VILLAGE OF GERMANTOWN
N112 W17001 MEQUON ROAD, GERMANTOWN, WI 53022

MEETING:	PLAN COMMISSION
DATE AND TIME:	MONDAY, November 8, 2021 6:30 p.m.
LOCATION:	Germantown Village Hall Board Room, N112 W17001 Mequon Road

- D. TR Capital, LLC, Agent and Property Owner of W219 N11588 Appleton Avenue. Site Plan Review for re-development of a 3.65-acre commercial self-storage facility. **[ACTION]**

EROSION CONTROL DETAILS

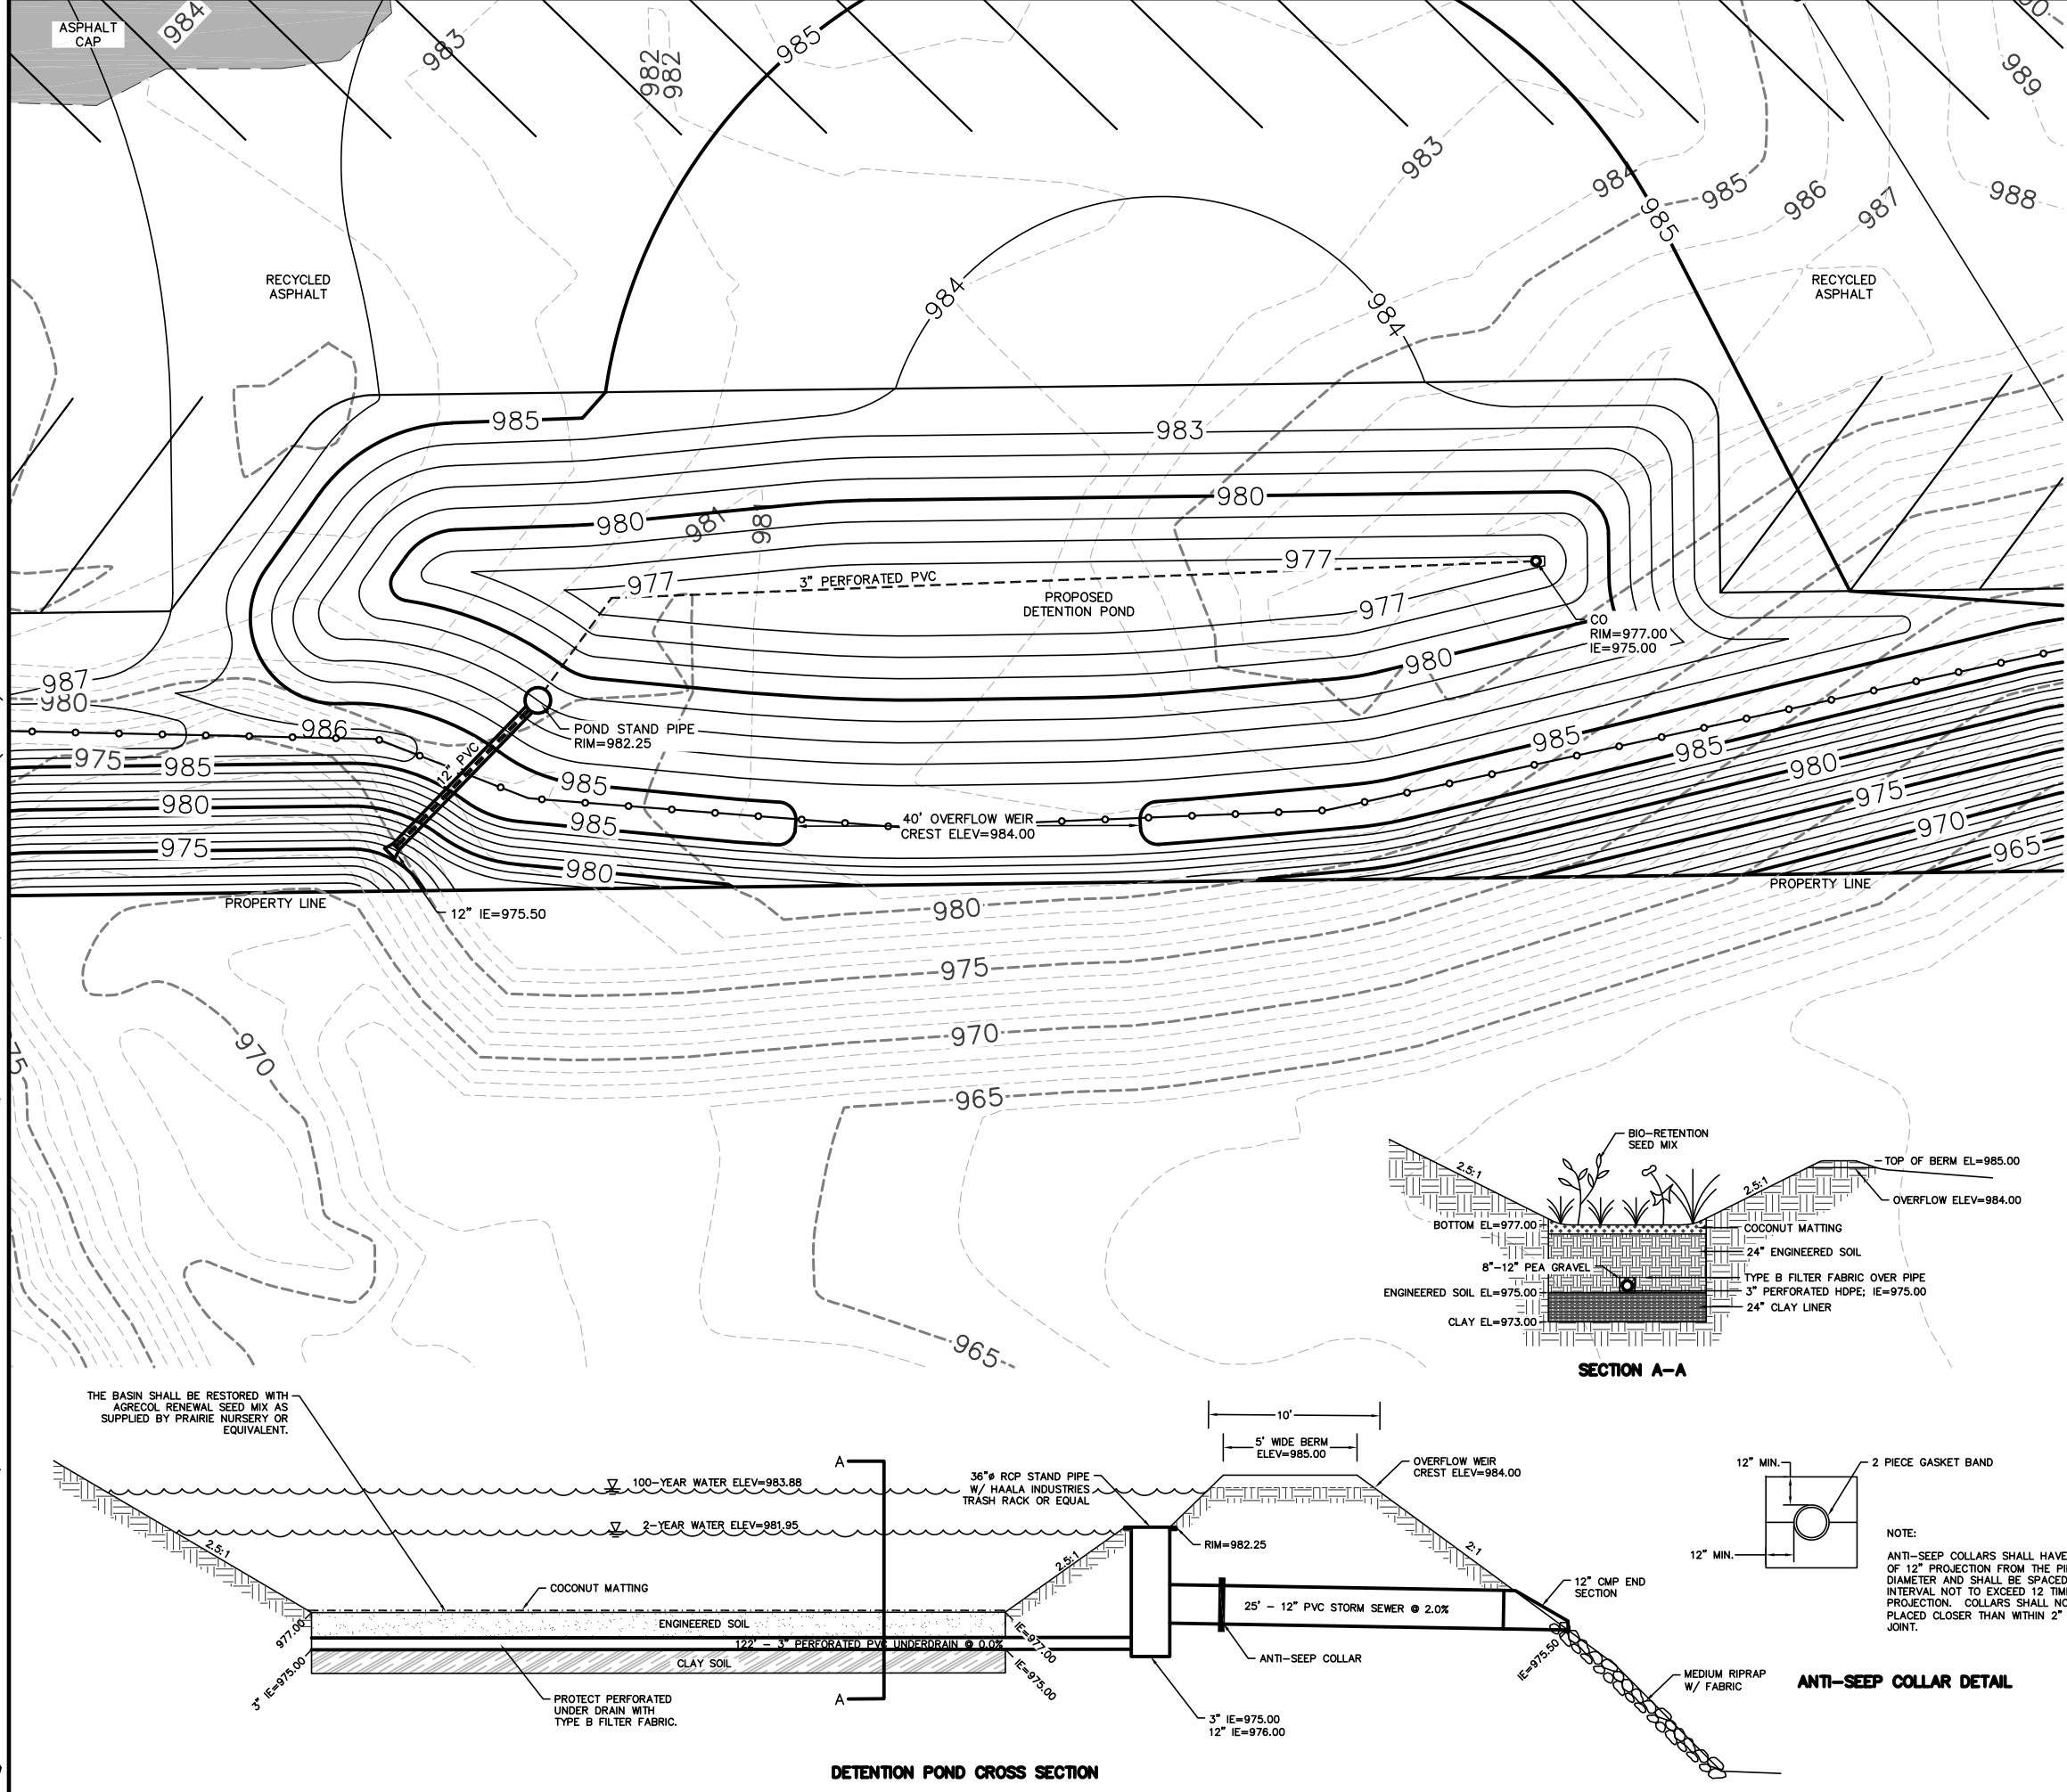
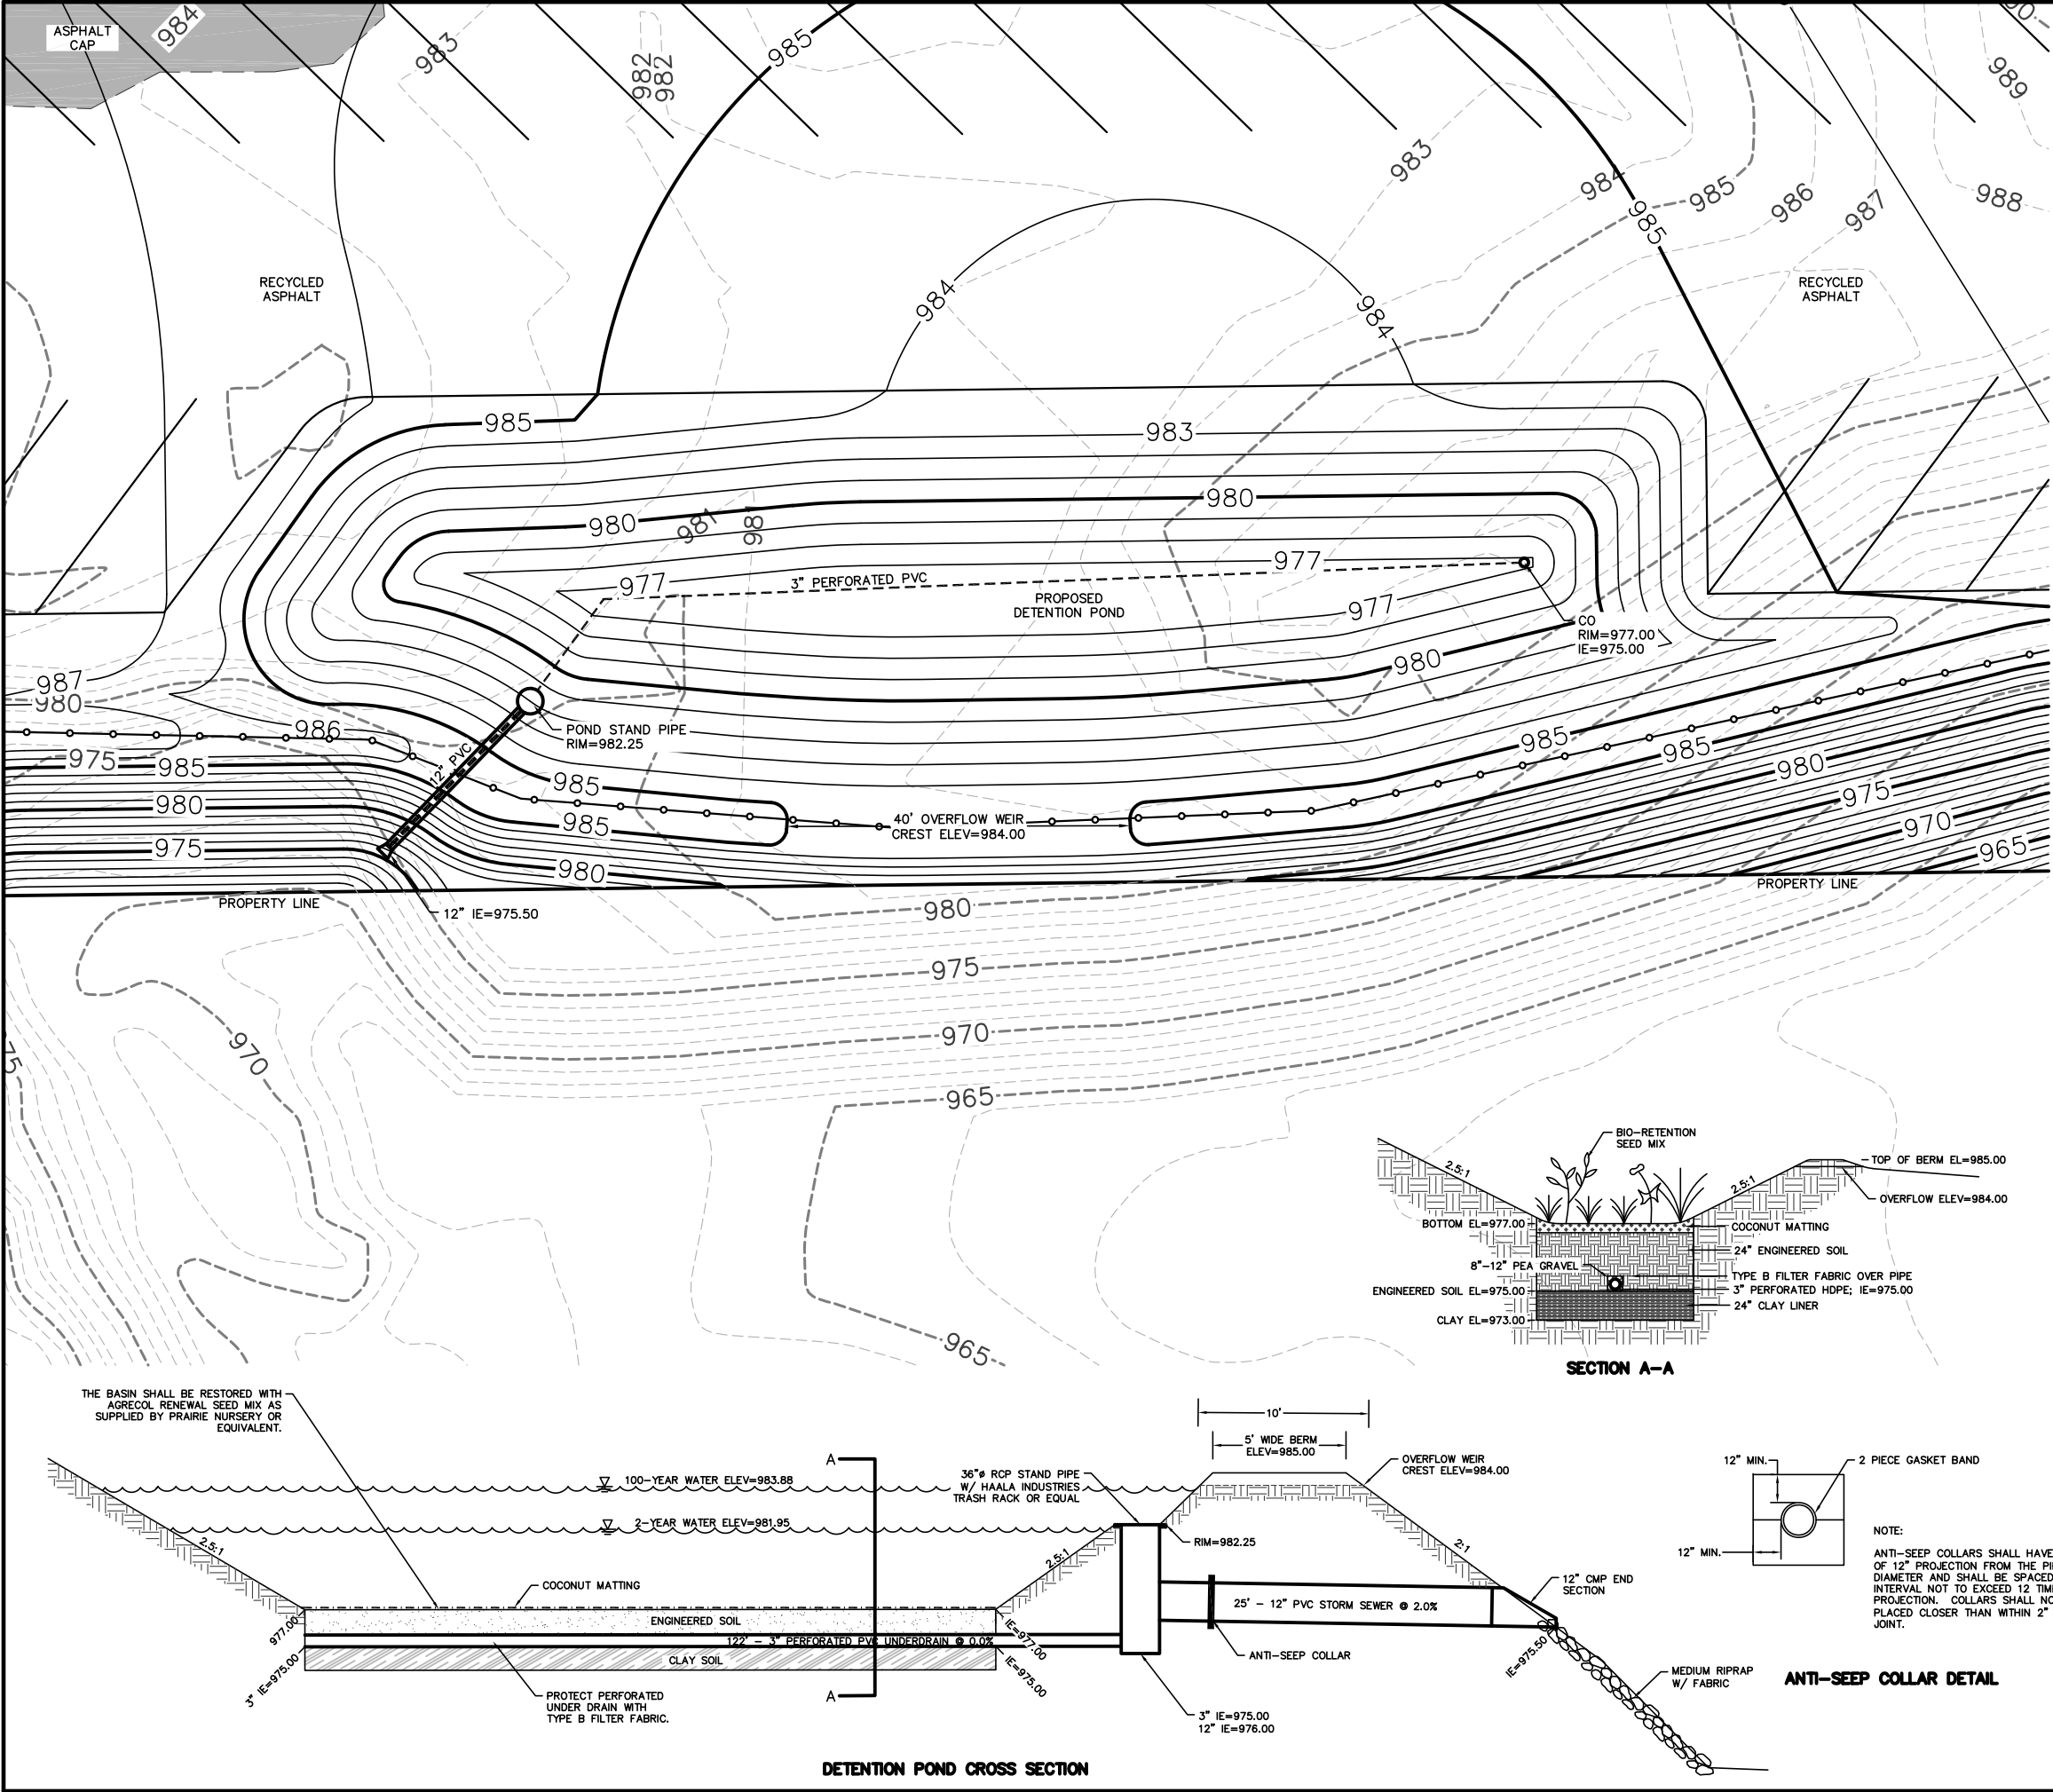
1. How will the rip rap stilling basin show be installed on the steep slope. [Riprap will be installed on the steep slope as shown on the detail provide on Sheet C-105.](#)

1. How will the rip rap I stilling basin show be installed on the steep slope? [Riprap will be installed on the steep slope as shown on the detail provide on Sheet C-105.](#)
2. Berm top width shall be a minimum of 10' [The berm width is 10 feet at the 100-year storm elevation which should meet the requirements. The biofilter is accessible to be maintained from the parking area so access is not required along the berm to maintain the device.](#)
3. Berm shall include a core trench or keyway per WDNR technical standards. [A keyway is required for wet detention ponds, so the bio-filter should not require a keyway this there is not a permanent wet pool. The outlet pipe does include an anti-seep collar to prevent seepage through the berm.](#)
4. Provide permanent erosion control protection for the overflow spillway. [TRM is shown on the overflow spillway on Sheet C-104.](#)

GRADING PLAN

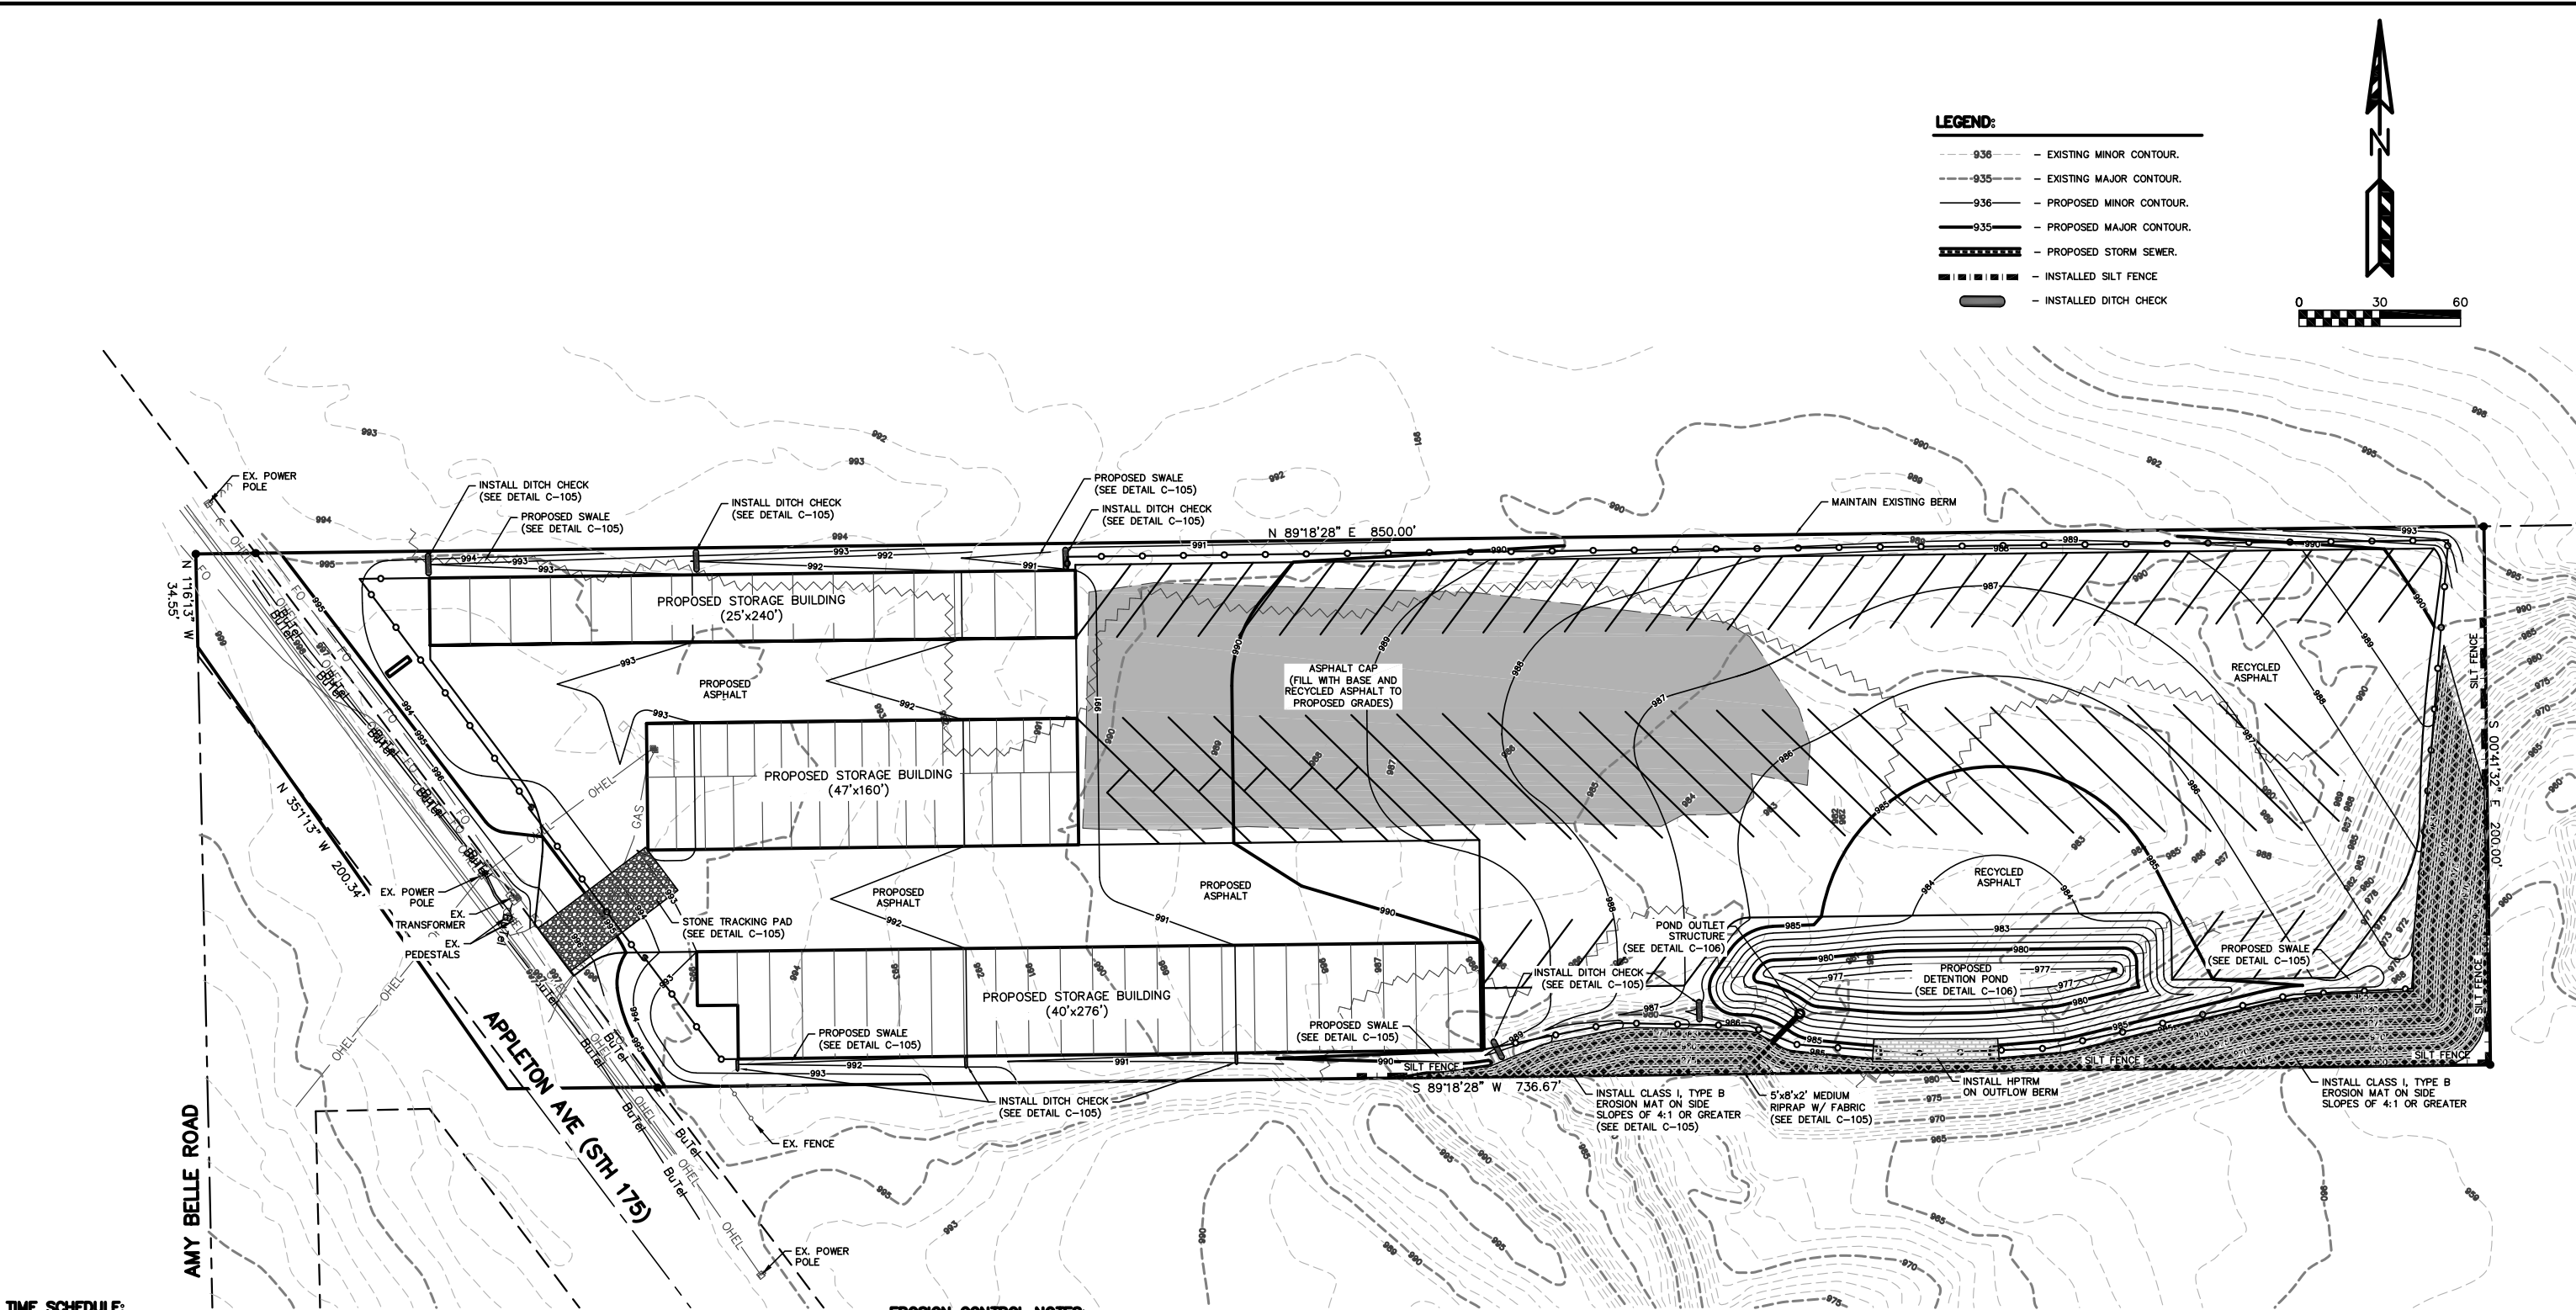
1. Chapter 17.45(1)(c) requires an 8' wide greenbelt between parking areas and all property boundaries. Please modify the paved parking area along the north property line to at least meet this requirement. (See the recommended setback from the village Forester for preserving the trees along the north property line.) The tree line to the north is essential for screening.
[The plans have been revised to provide an 8' wide greenbelt between the parking areas and property boundaries, see Sheet C-102.](#)

2. The setback of 10' from buildings to the side property lines is insufficient for this site. Landscaping should be added to the area between the buildings and the fence line to provide adequate screening of the site.
[Landscaping has been added to the north side of the 25'x240' building to provide adequate screening. See Sheet C-107.](#)

4. The site shall be fully enclosed by a 6' chain link fence. Please connect the fence on the east end of the property. [The fence has been enclosed as requested and is shown on Sheet C-102. The fence along the north and south buildings has been modified to use the building face as a fence.](#)
